WMGO – Retrofitting Tire Pressure Monitoring (TPM) Control Unit (Stop Delivery)

Model Line: **Taycan (Y1A/Y1B)**

Concerns: **Tire Pressure Monitoring (TPM) control unit**

Installation position of TPM control unit

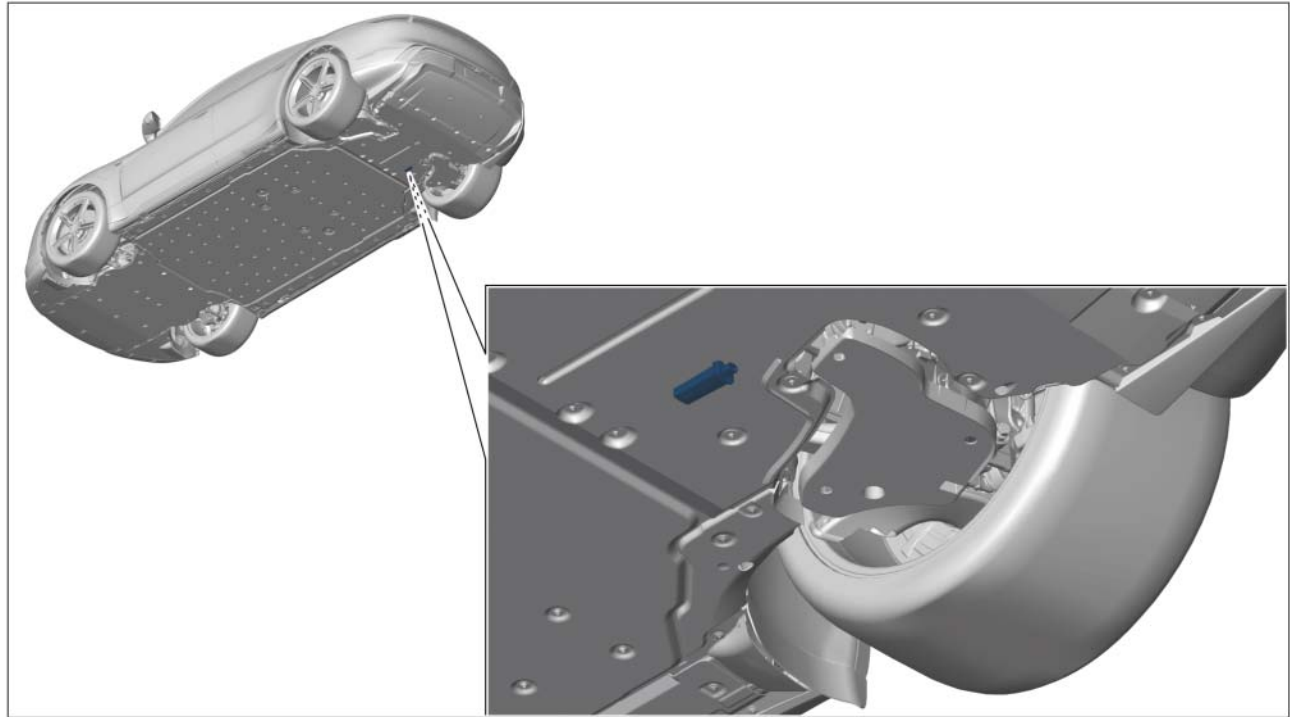
Information: **Due to worldwide semiconductor shortages experienced by some suppliers, the affected vehicles were built without the control unit for the Tire Pressure Monitoring (TPM) system.** The Tire Pressure Monitoring (TPM) system is therefore not available on these vehicles.

Action required: Retrofit Tire Pressure Monitoring (TPM) control unit.

– Tire Pressure Monitoring (TPM) control unit (**retrofit**)

- Work Procedure: 1 Raise the vehicle on a lifting platform.
⇒ *Workshop Manual '4X00IN Lifting the vehicle'*
- 2 Remove rear underbody cover.
⇒ *Workshop Manual '519419 Removing and installing cover for rear underbody'*
- 3 Install Tire Pressure Monitoring (TPM) control unit.
⇒ *Workshop Manual '443419 Removing and installing Tyre Pressure Monitoring (TPM) control unit'*
- 4 Install rear underbody cover.
⇒ *Workshop Manual '519419 Removing and installing rear underbody cover'*
- 5 Lower the vehicle.
